Re: Port Phoenix Water Way Marina
DCI2023-00054 - Major PD

The Zoning Section has reviewed the information provided for the above zoning application. The Land Development Code requires additional information for the application to be sufficient. Please respond to each requirement not satisfied on the attached checklists. For your assistance, we have enclosed any additional memoranda from the various Lee County reviewing agencies.

MASTER CONCEPT PLAN
FOR
PORT PHOENIX
SAFE HARBOR MARINAS
LEE COUNTY, FLORIDA

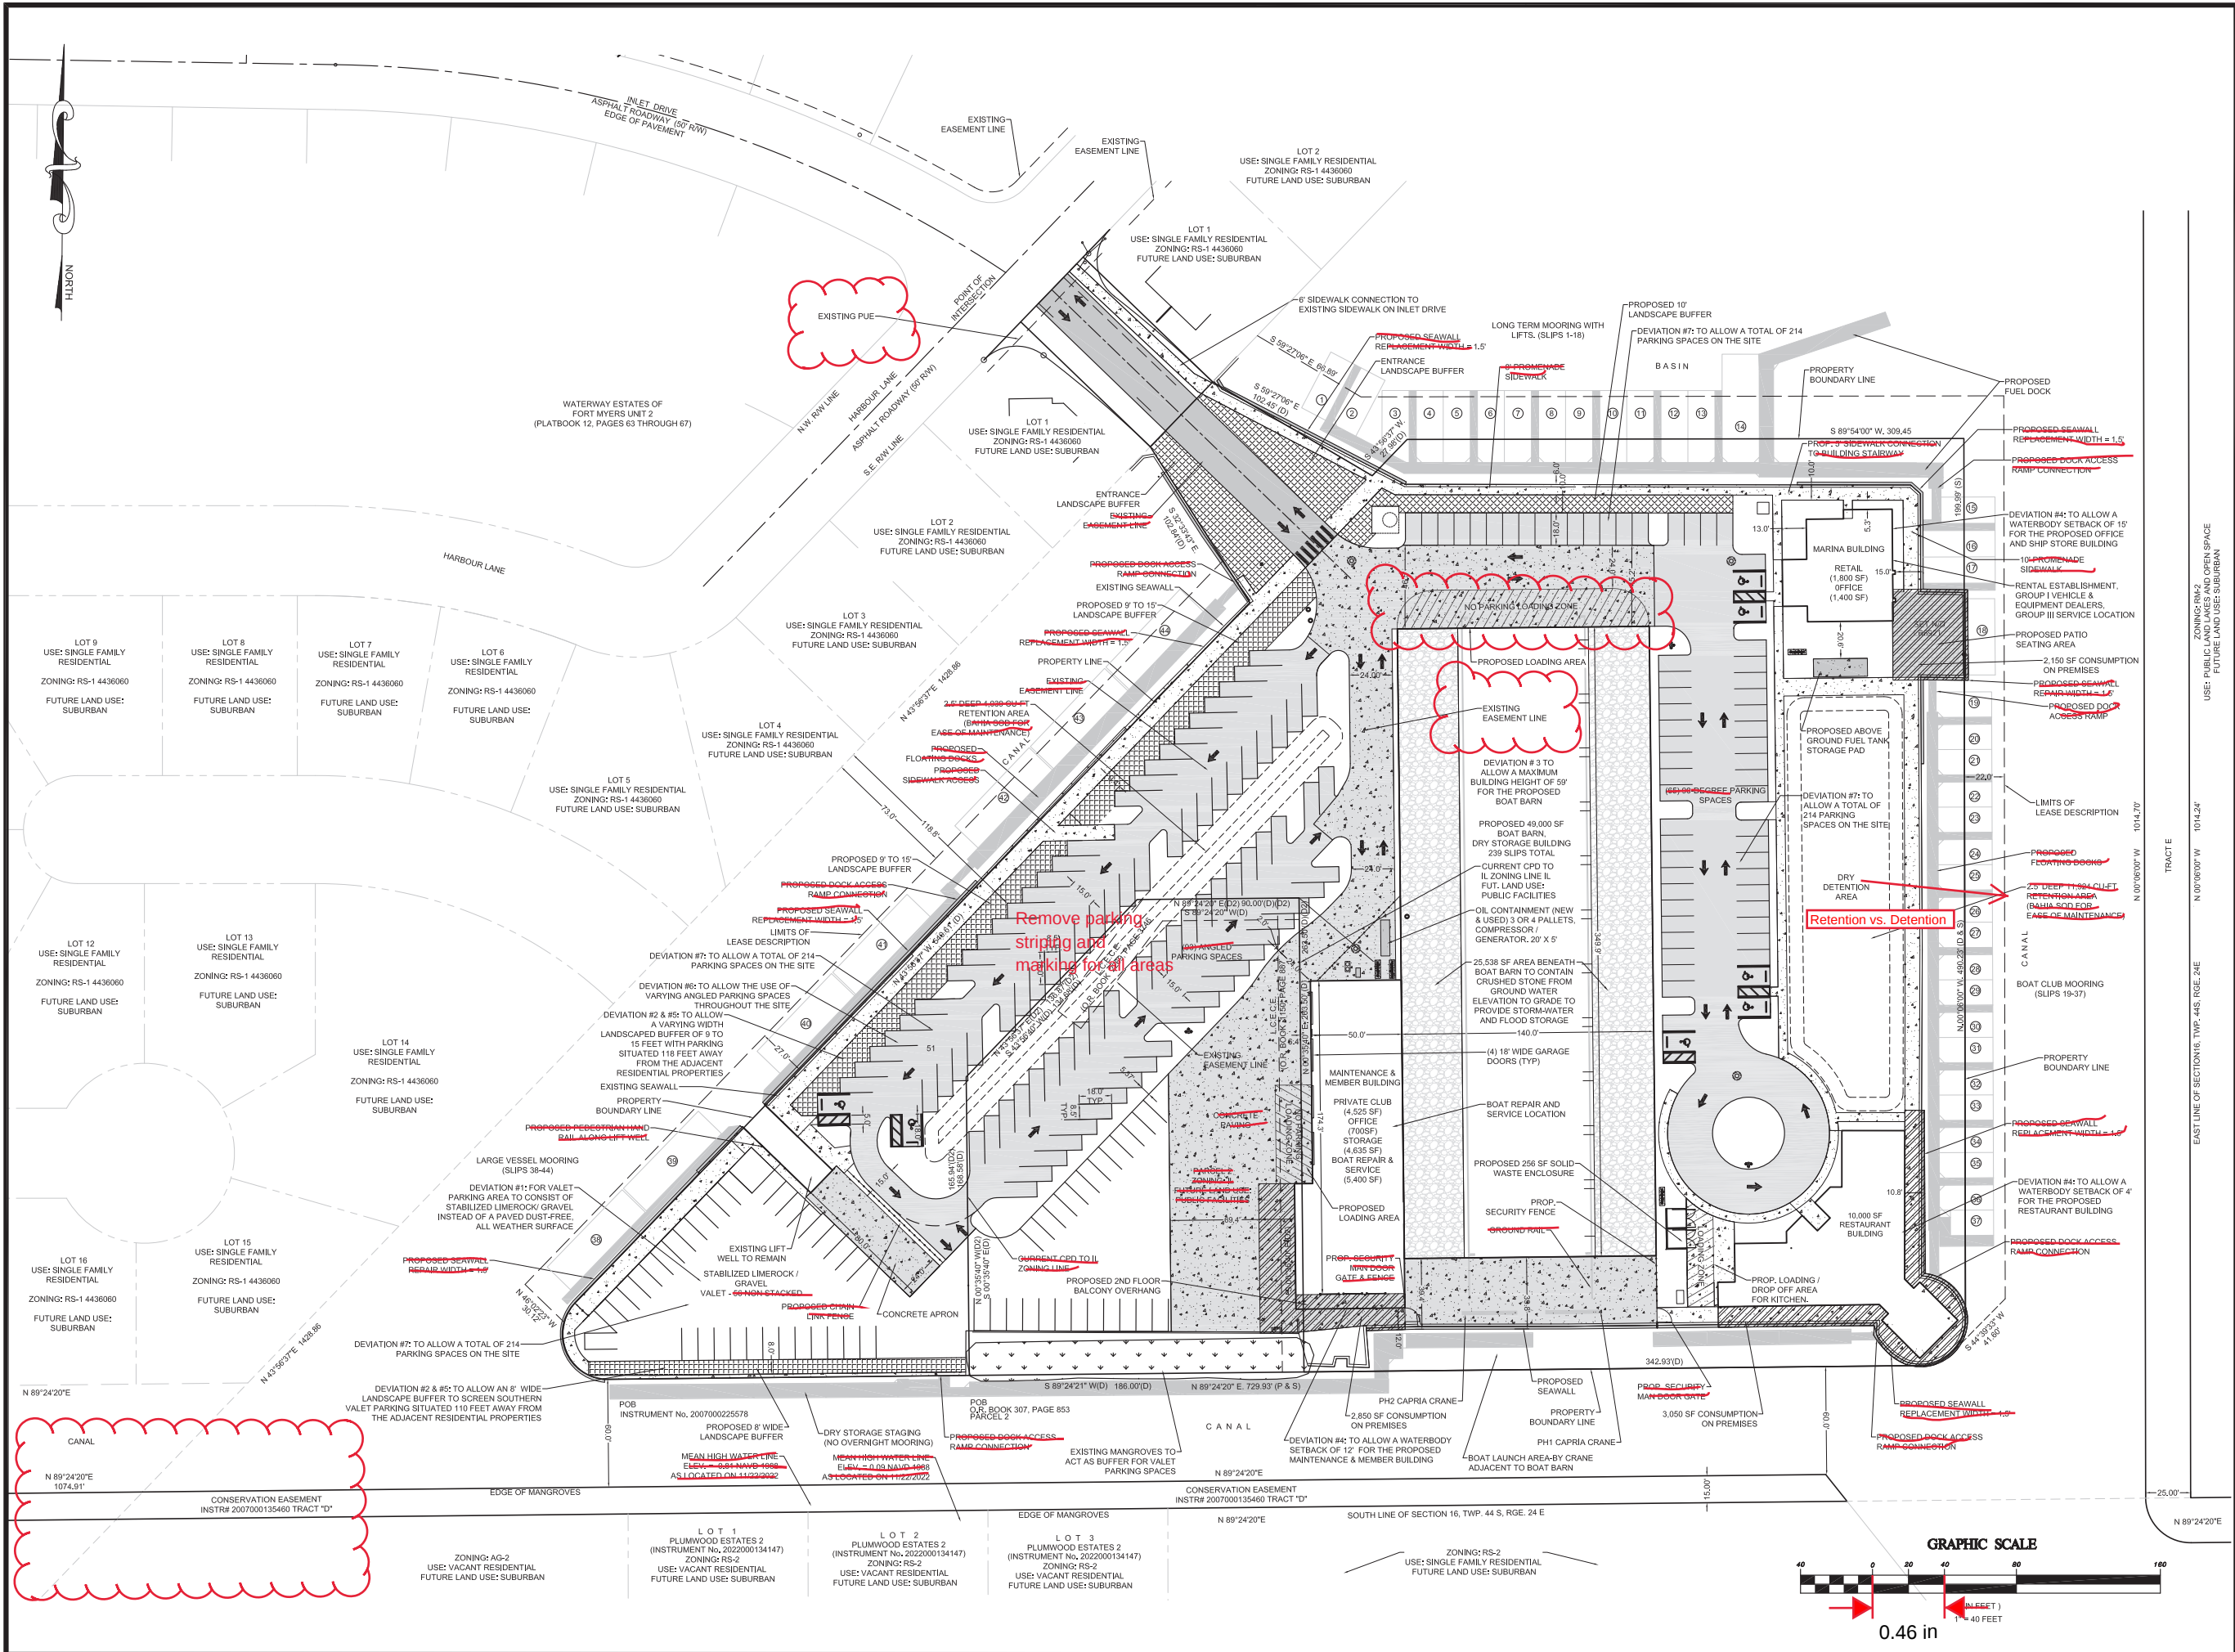
3. The MCP contains information that is not required in LDC 34-373(a)(6). Please revise the MCP to only include the necessary information. Staff has attached suggested revisions.

4. The conservation easement is not correctly reflected on the MCP. Please revise the MCP to correctly reflect the property being rezoned. Please provide a darkened line that clearly indicated the entire area to be rezoned. See Legal comments below for additional information.

1. The MCP uses and square footages are not consistent with the TIS. The outdoor seating should be included in the trip generation. Will there be additional outdoor seating around the restaurant as hatched out on the MCP? The 4,635sf of storage associated with the marina LUC needs to be separated based on the LUC description for Marina. Will it be used for the repair center?

3. Revise the Master Concept Plan to depict deviation 3a, 3b, etc.
4. Cross sections for particular property lines have been provided. Revise to provide cross sections for each area that the applicant is requesting a deviation from to provide details to demonstrate compatibility.
5. The entry road will need to be included in Deviation #3. Provide the details as described above.).
